From: [REDACTED]
Sent: 01 December 2025 17:51
To: Anna Tidey
Subject: Re: Planning application - DM/25/2311 Llain, 4 Nostel Priory Cottages, Balcombe
Attachments: Garden House.jpeg; Future Cladding (on approval).JPG; Mock up - Llain.png; Fable & Bloom - Black frames.jpg; Hedgerow Removal Enquiry.pdf

Subject: Planning application - DM/25/2311 Llain, 4 Nostel Priory Cottages, Balcombe

Rehau R7 Residence window in white foil grained finish

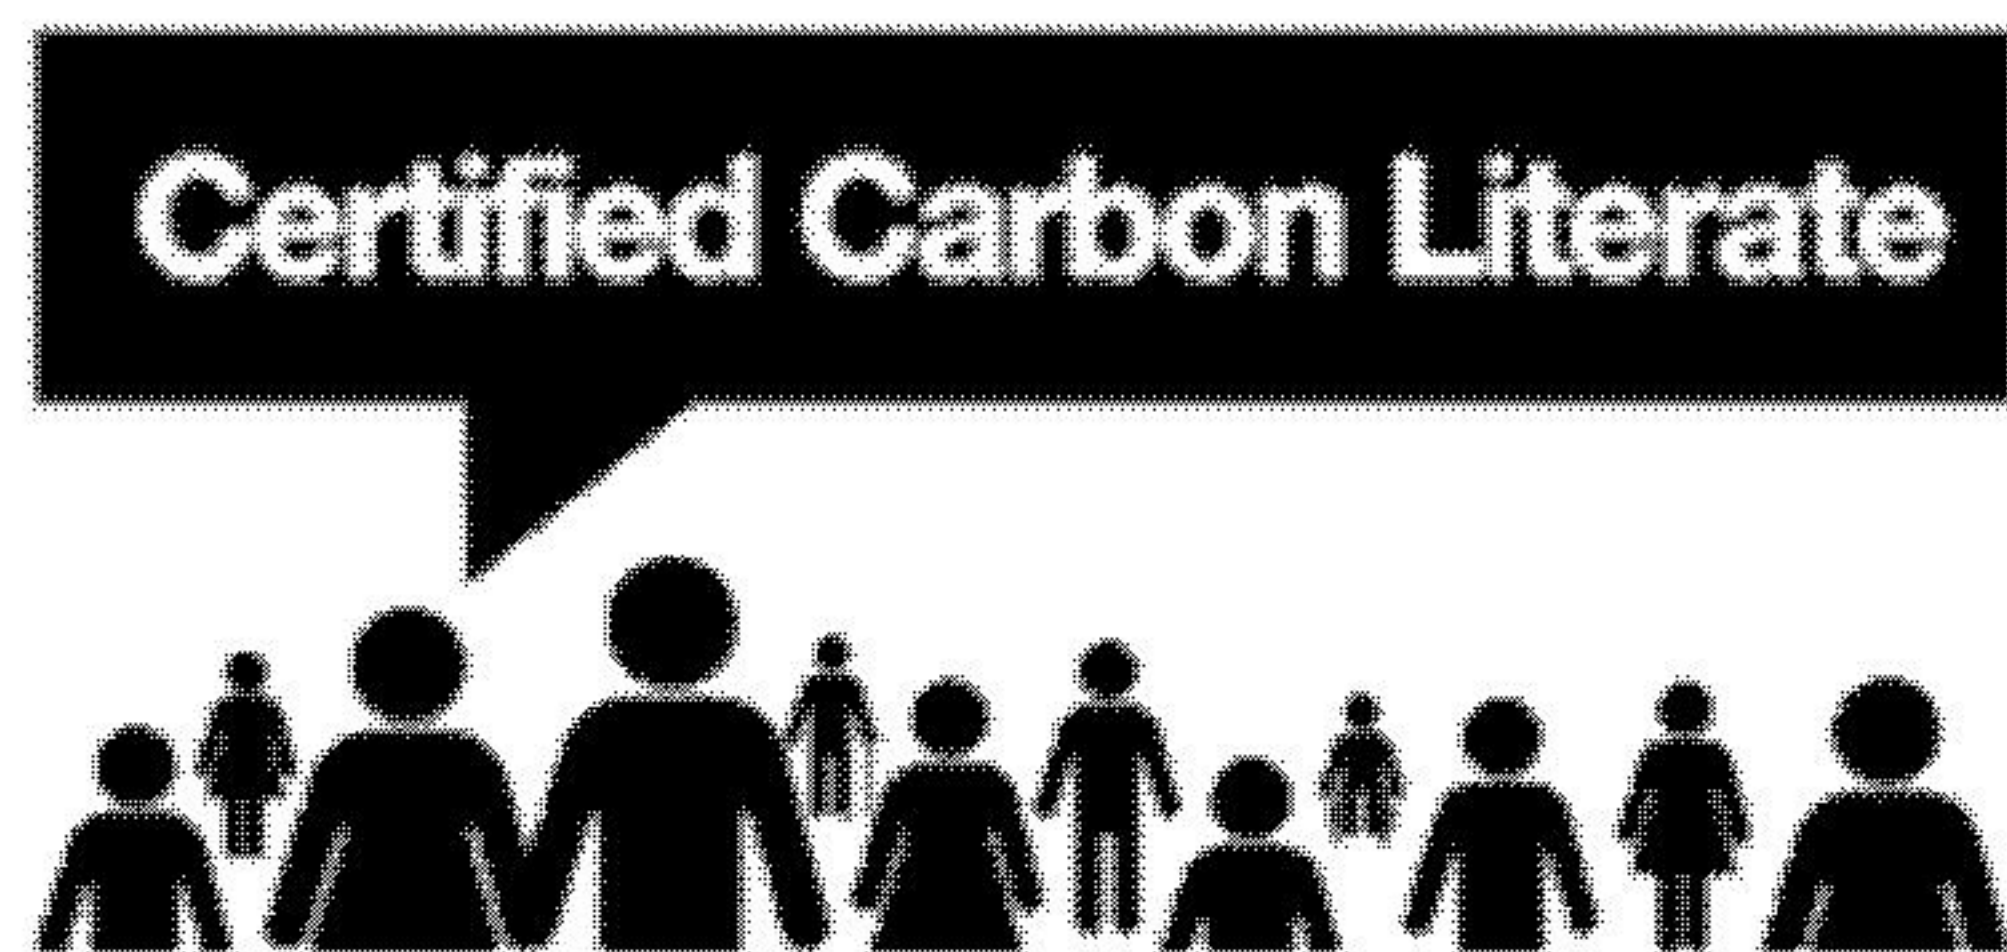
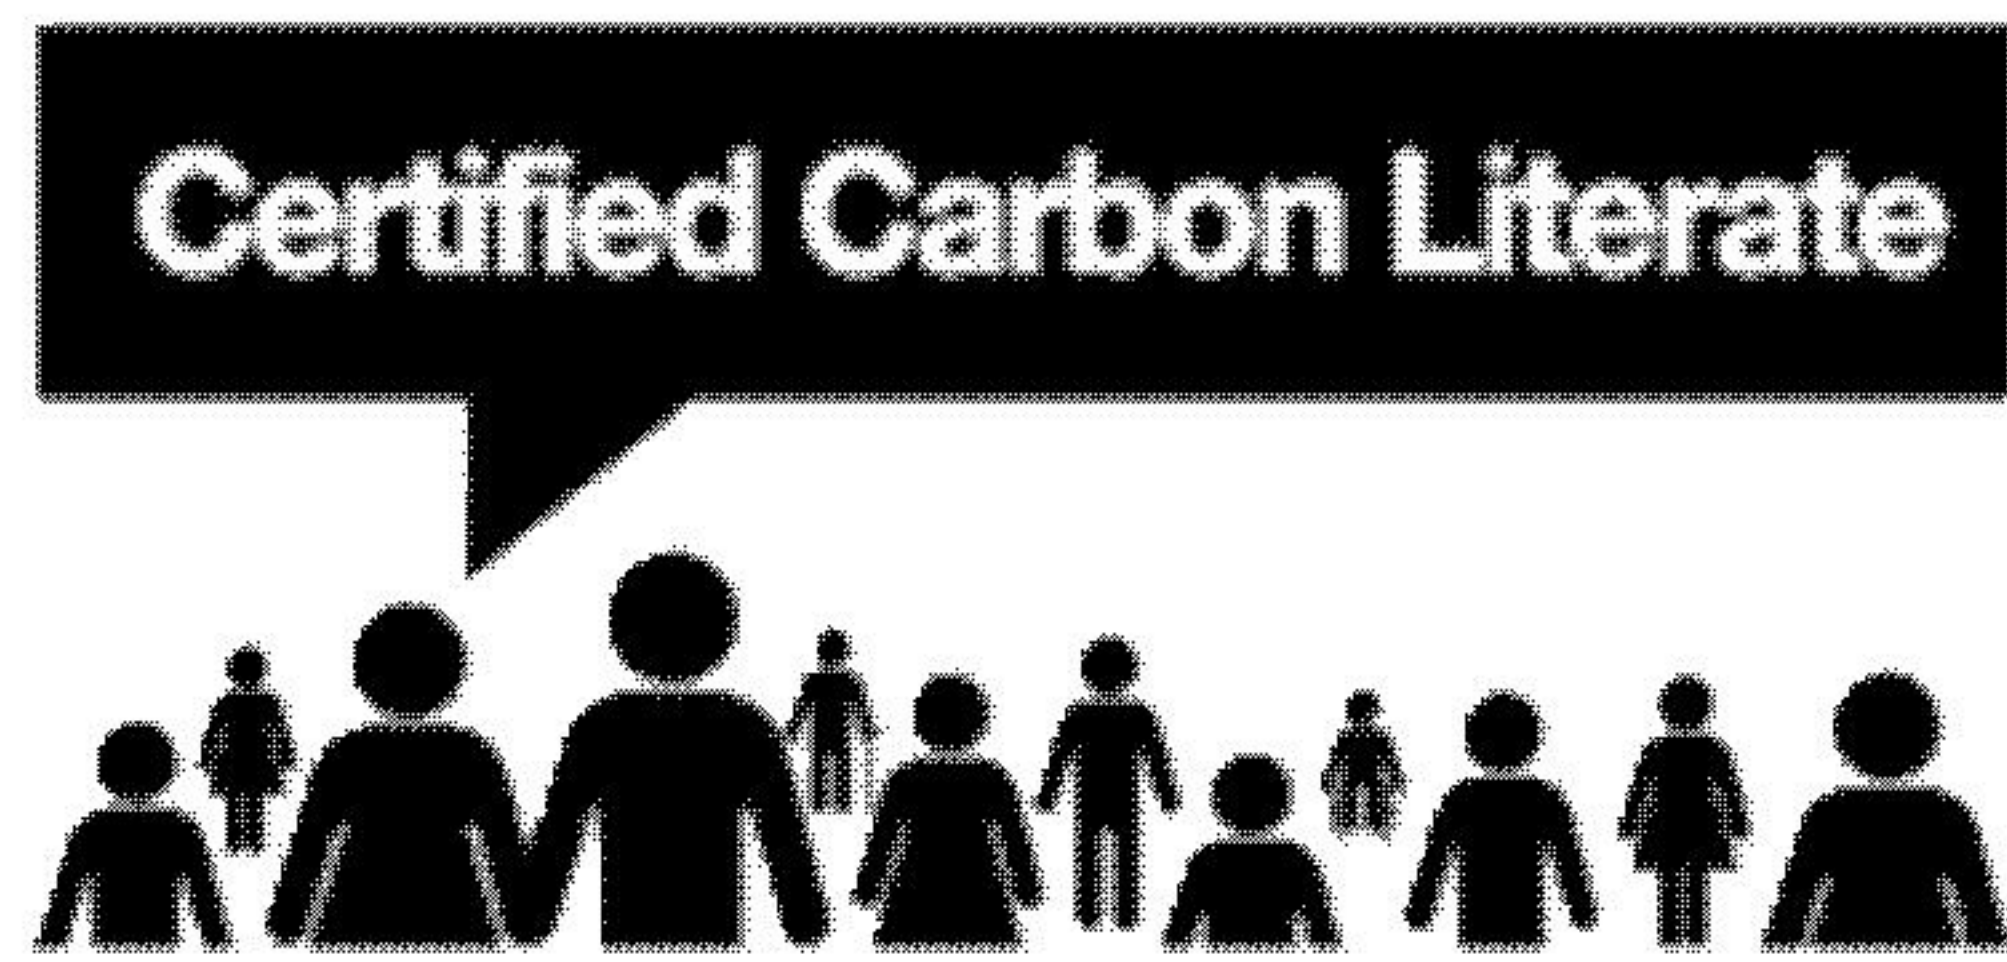
I mentioned another application at a house in Cuckfield where I have determined an application for replacement windows (Howdean, High Street, Cuckfield, under application DM/25/1690). In that case the house is located in a prominent position fronting the High Street and had shiny white UPVC replacement windows already installed. The Conservation Officer comments for that application are attached, for your information. Below I have reproduced the image and website link details for the white windows with a foil grained finish which were approved in that case, for your information.

Each planning application is determined upon its merits and in that case the proposed new windows were accepted as a replacement for white UPVC windows that had been installed without consent.
